ADDENDUM NO. 2
SEWER SYSTEM IMPROVEMENTS
CONTRACT 18-01
WATER TREATMENT PLANT IMPROVEMENTS
LIVINGSTON, TENNESSEE
WAUFORD PROJECT NUMBER 2068
CDBG PROJECT NO. 53789-12021

Date of Addendum: Tuesday, June 12, 2018
Bid Opening: Thursday, June 14, 2018, 2:00 P.M. Central Time

**HEADWORKS MODIFICATIONS
PLAN VIEWS**

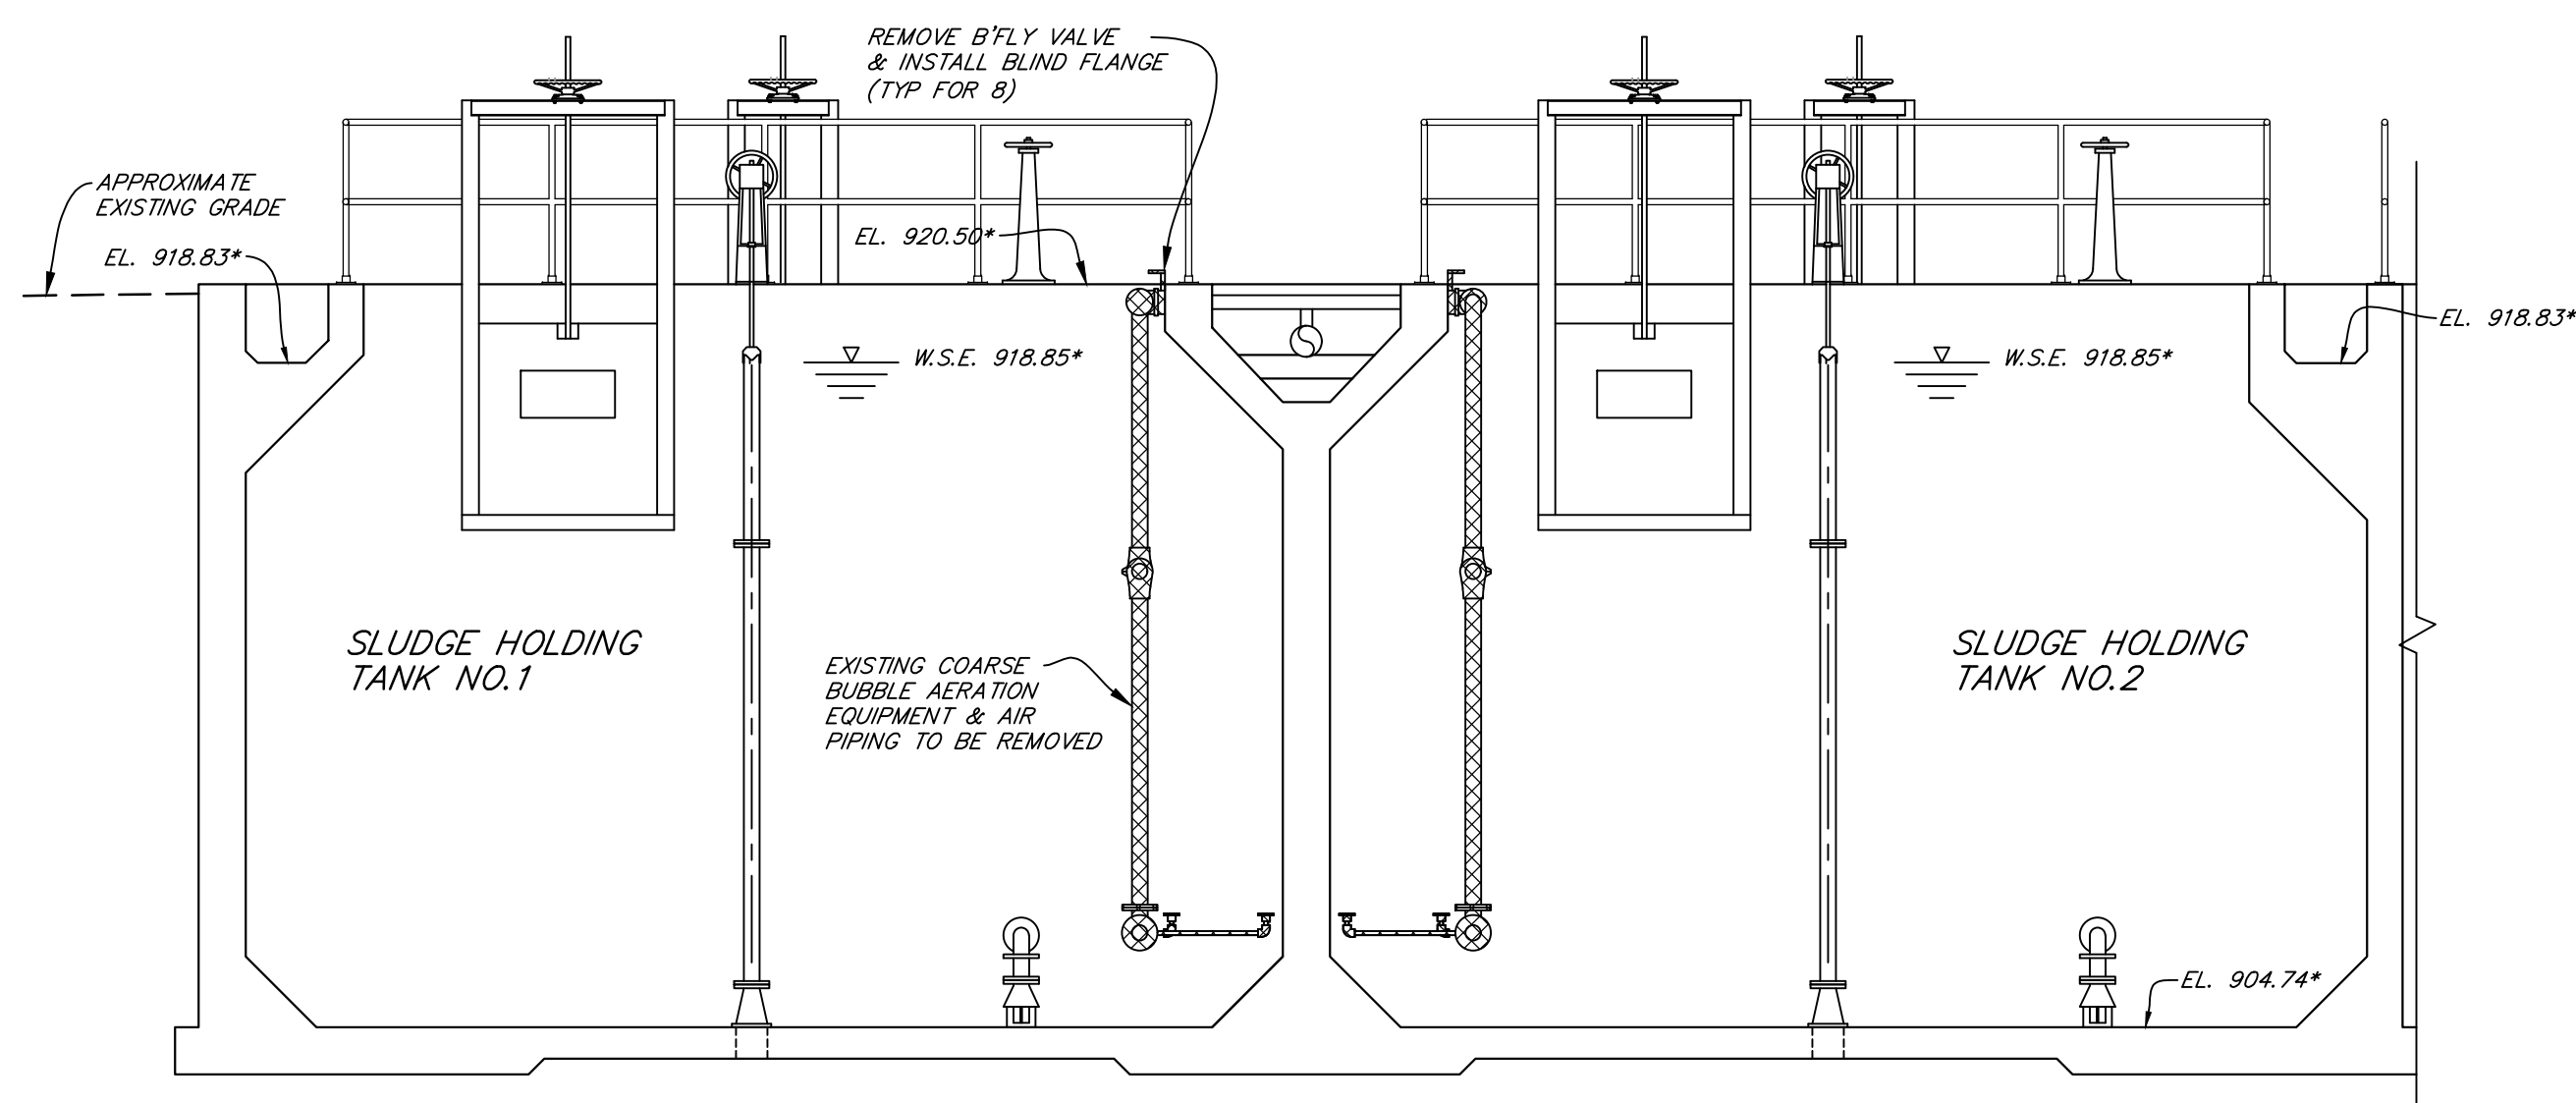
2. Plans, Sheet 2:

Modify as shown on the attached 8 ½" x 11" sheet.

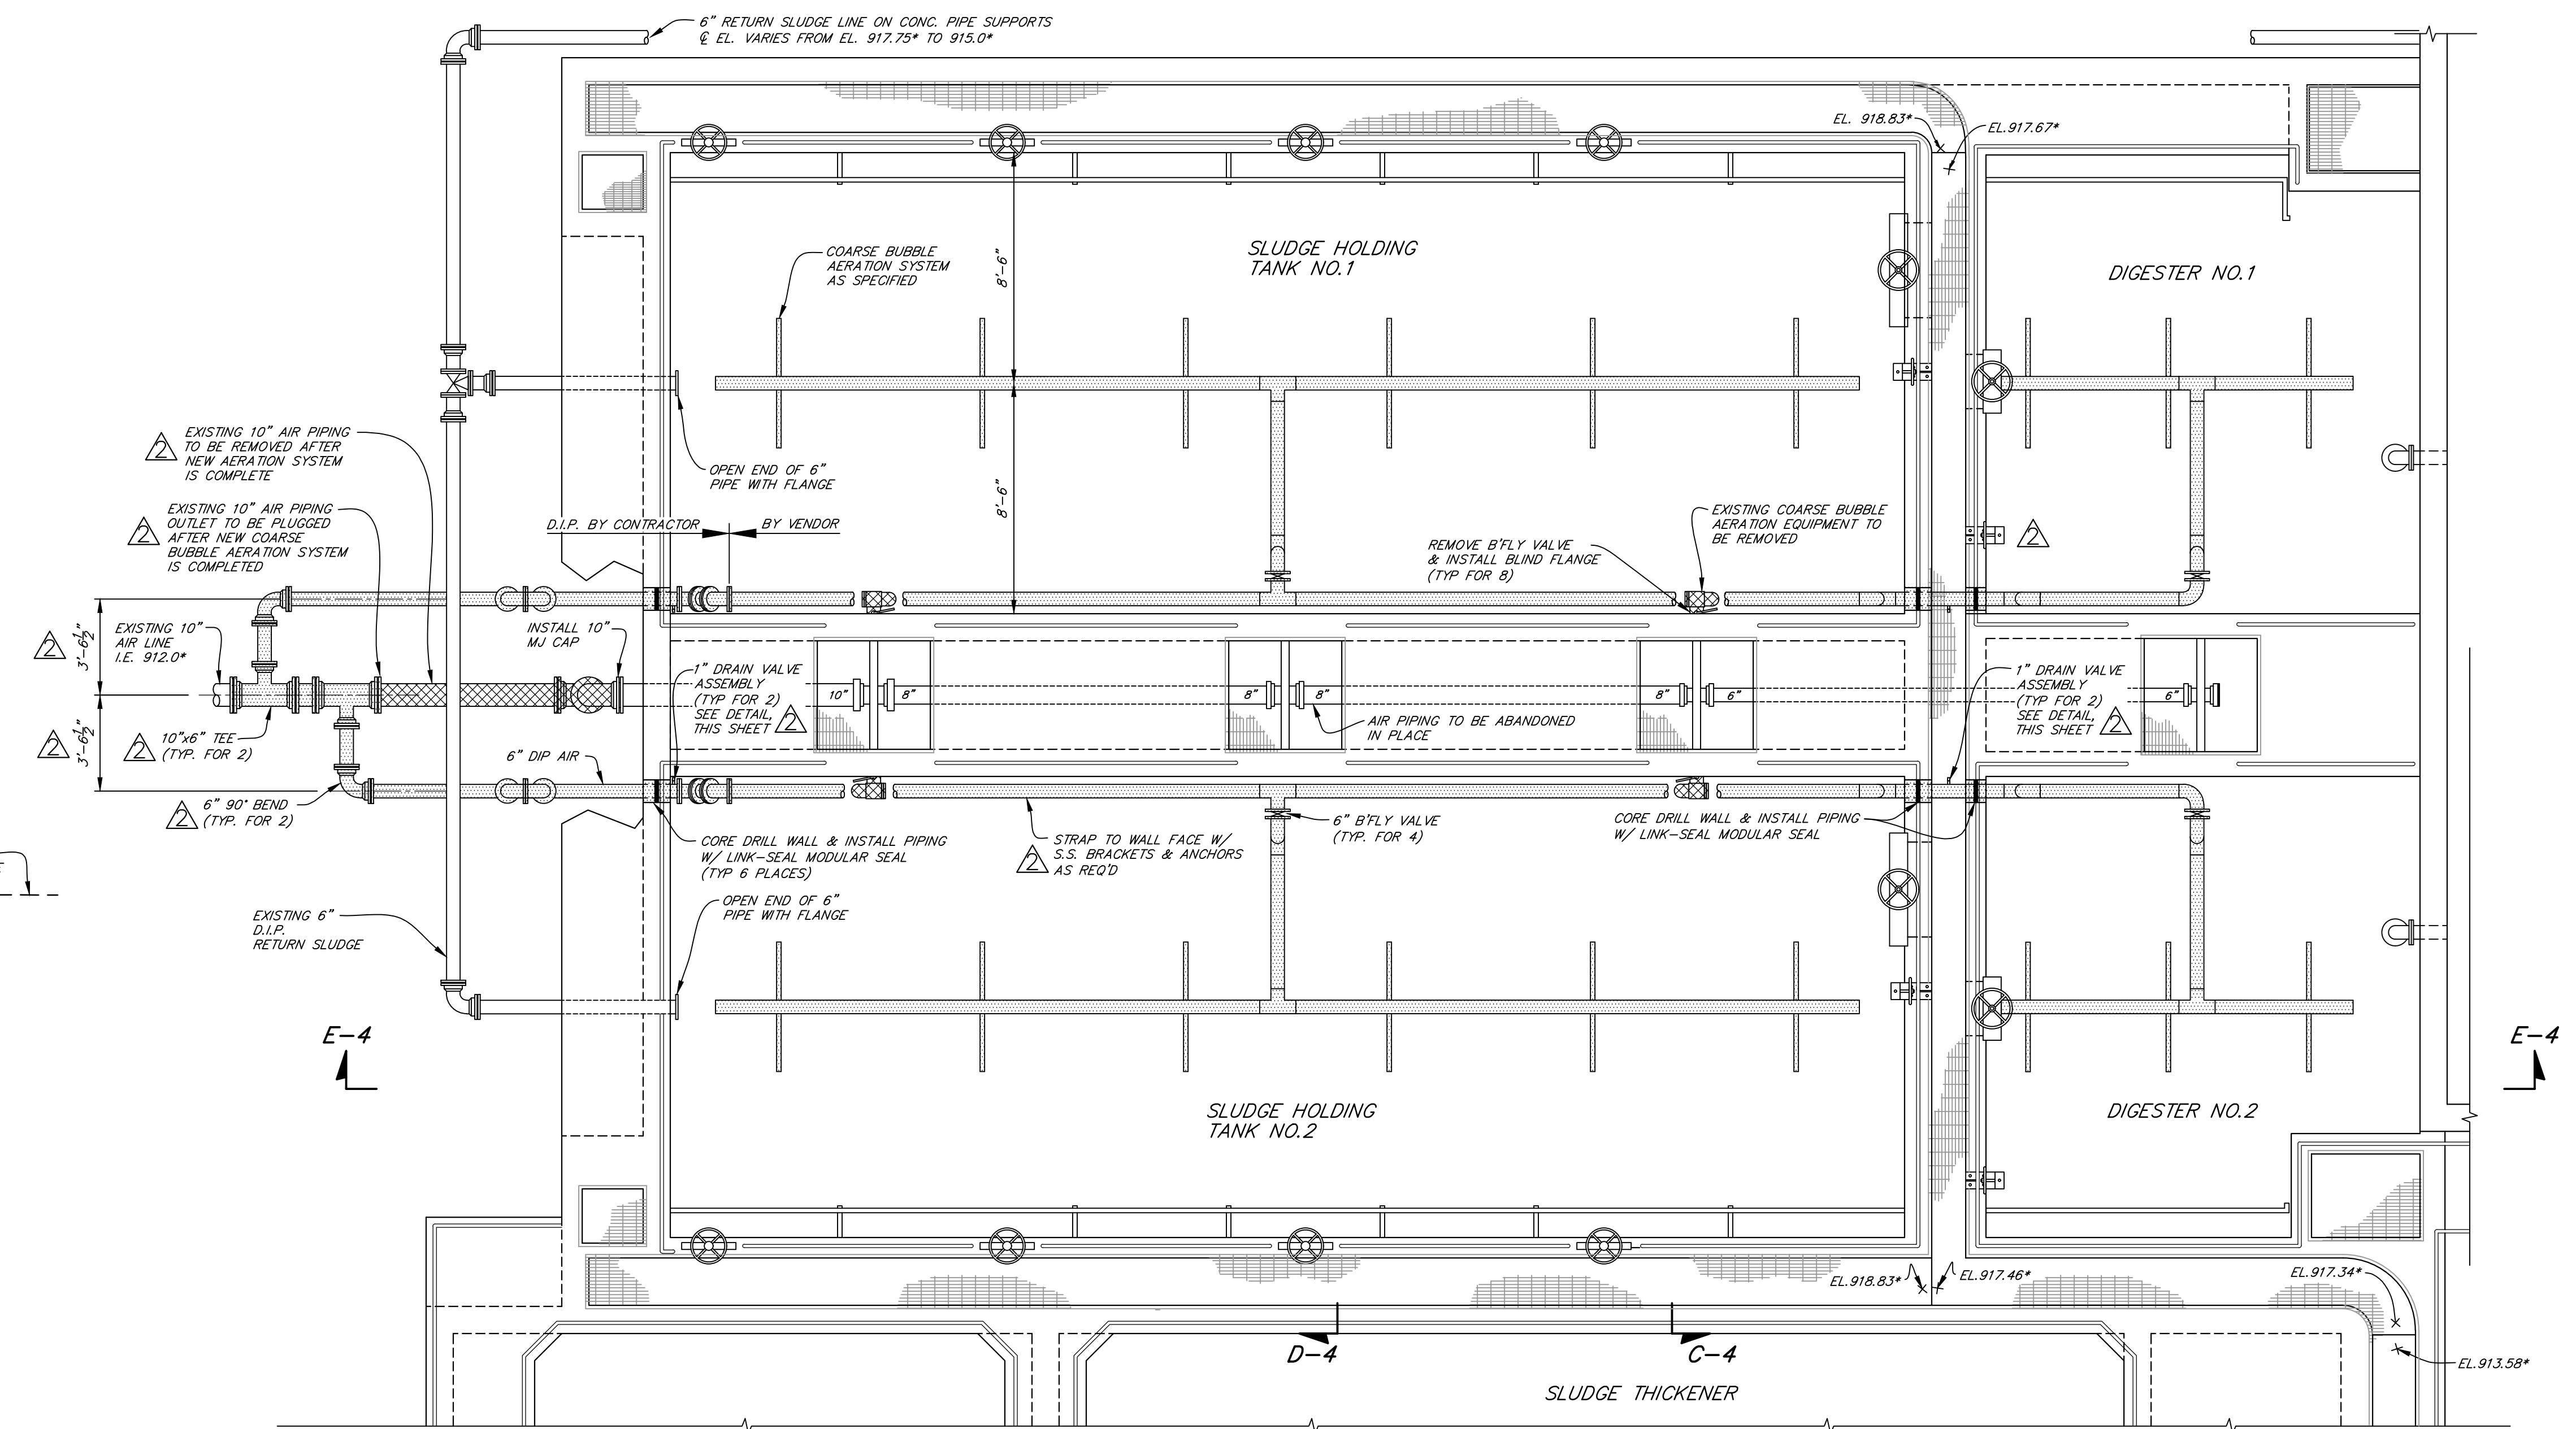
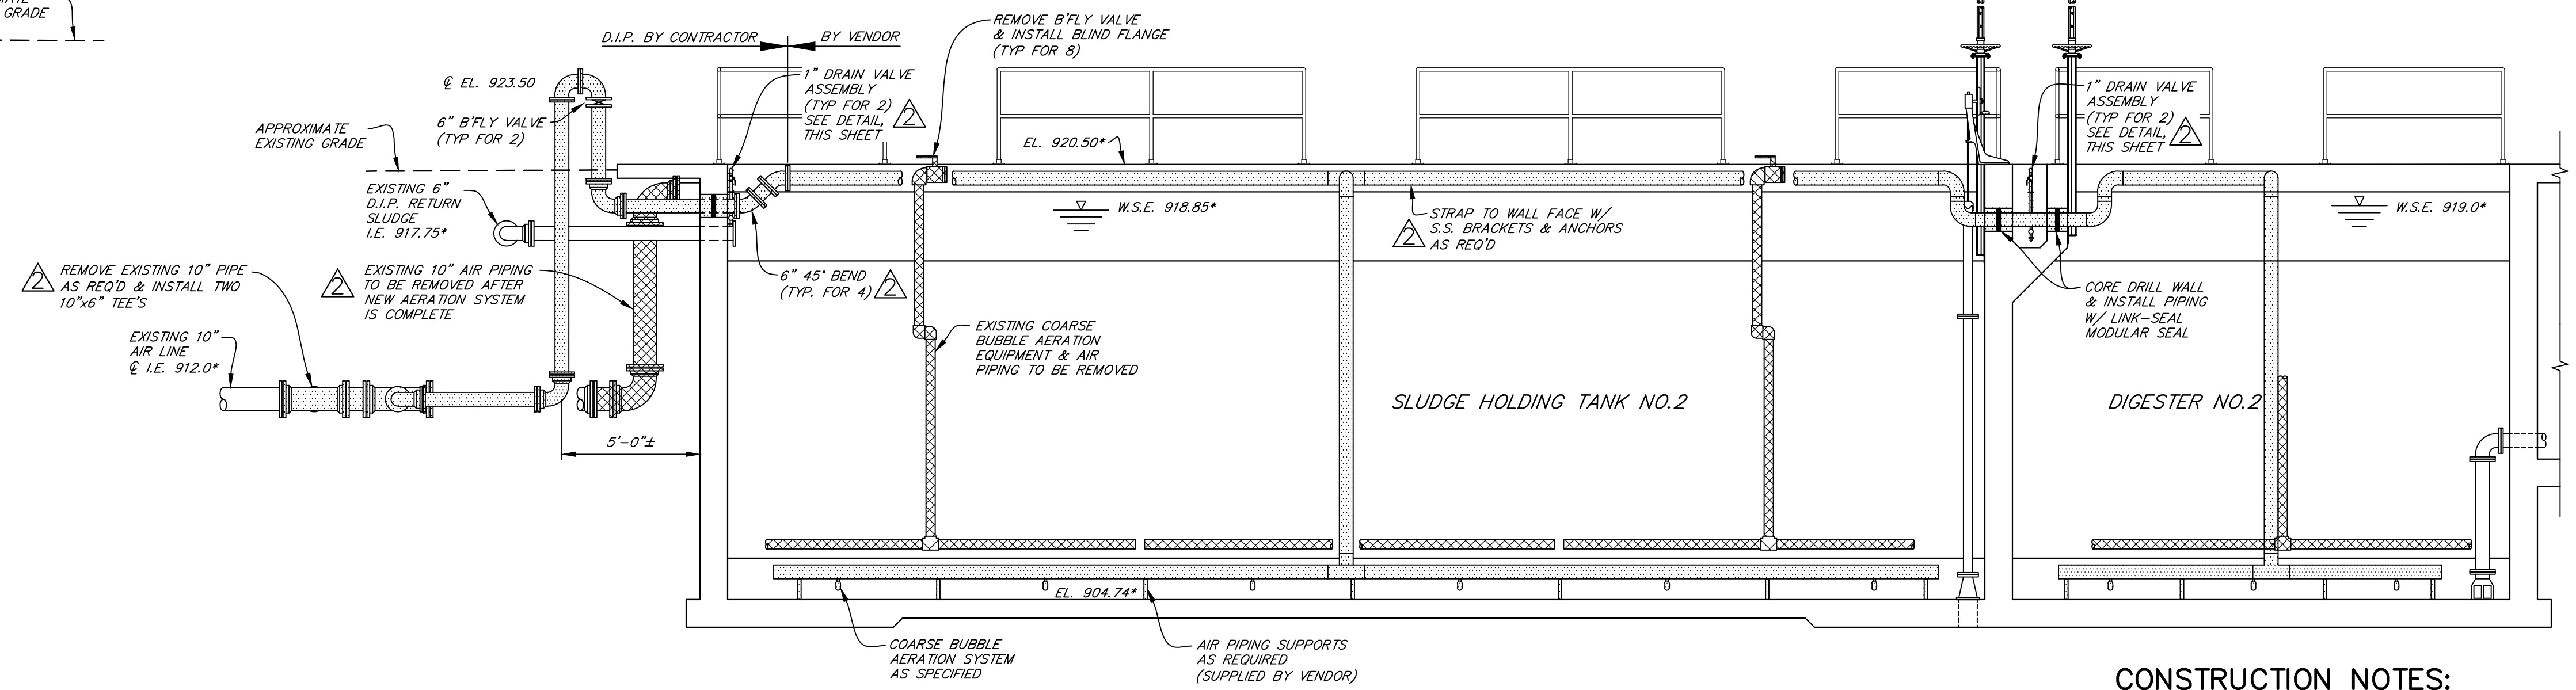
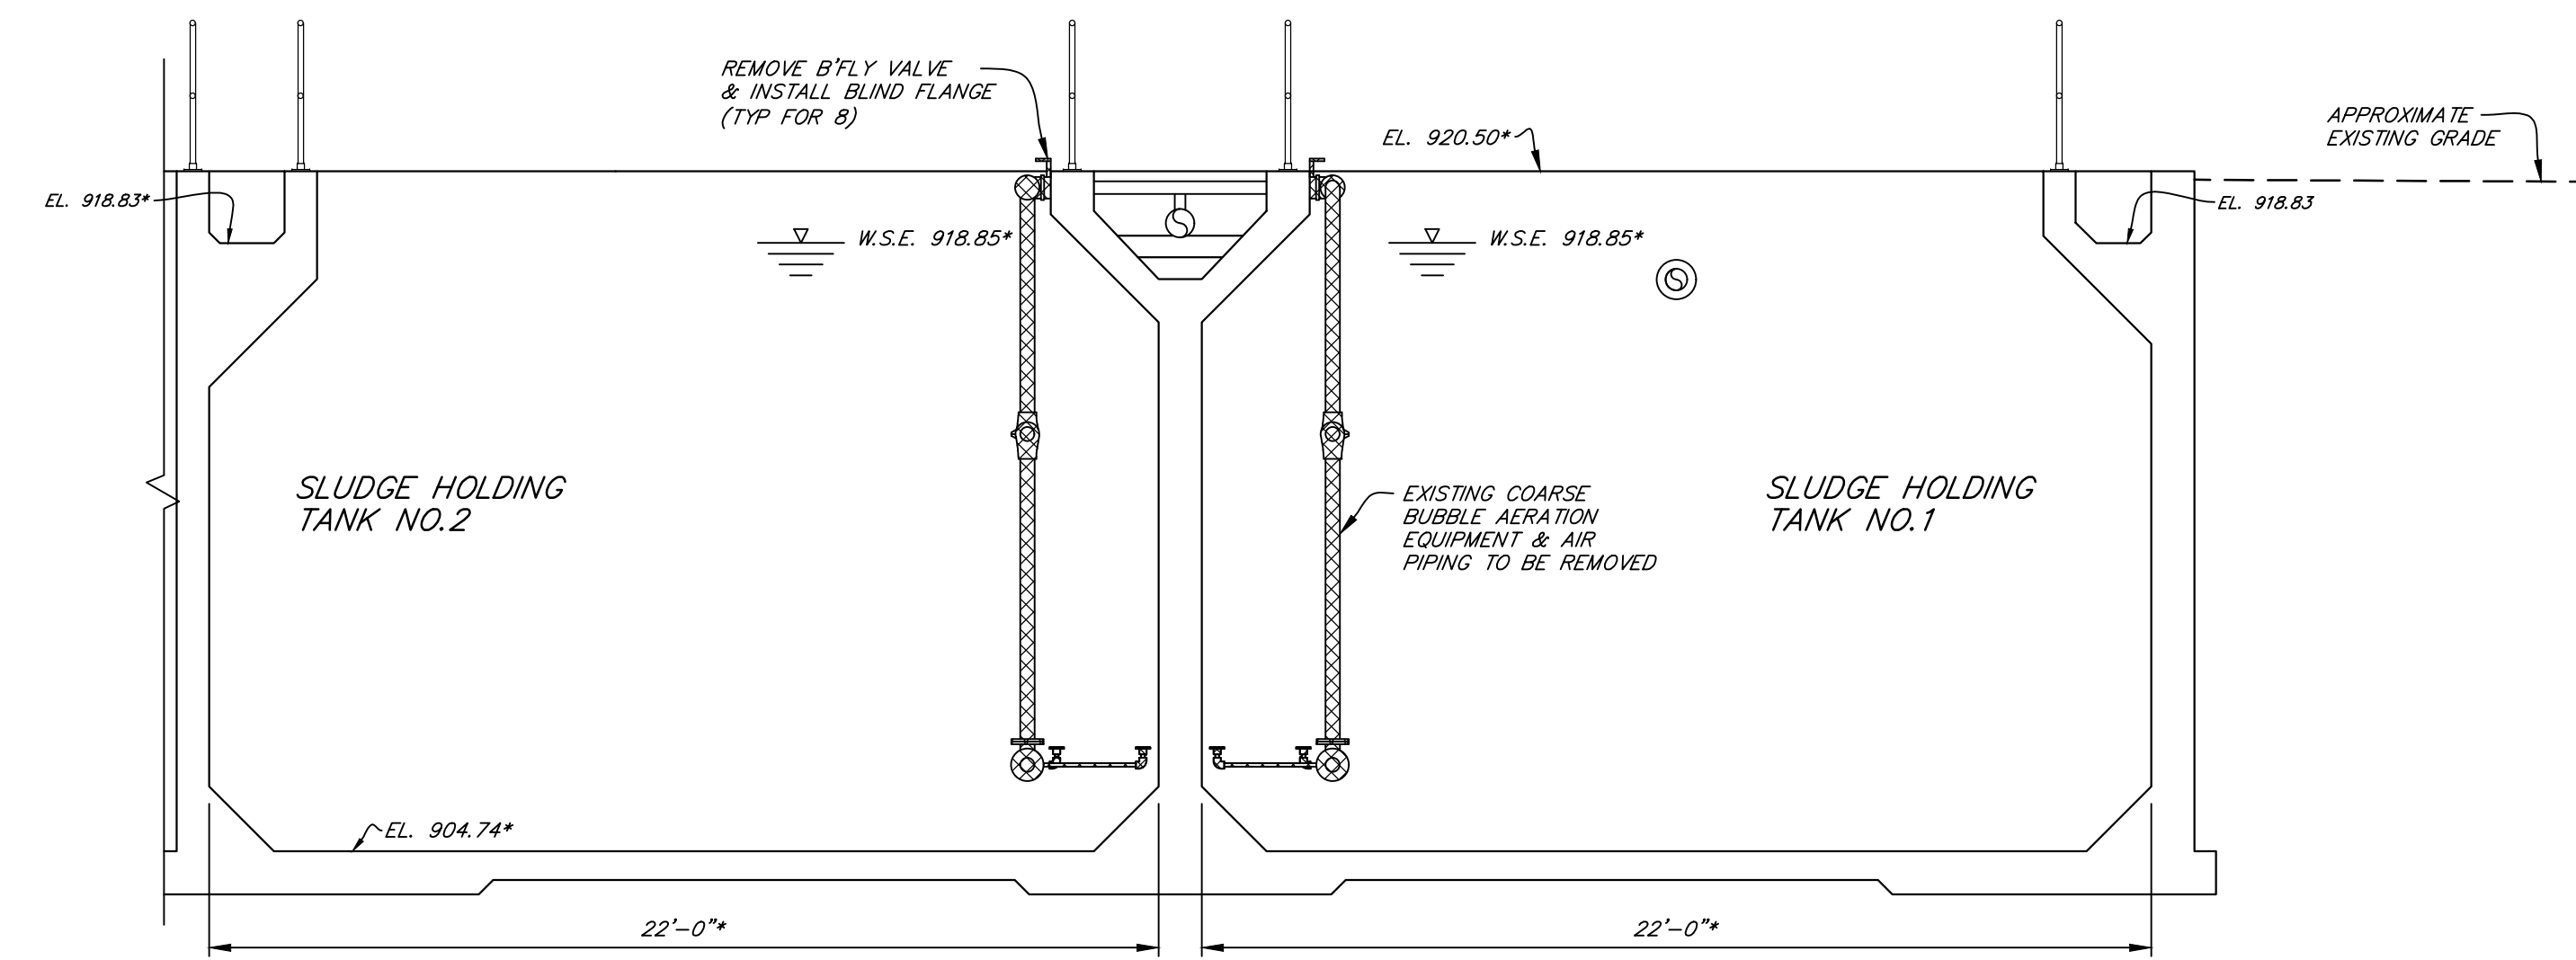
3. Plans, Sheet 4:

Modify as shown on the attached 30" x 42" sheet.
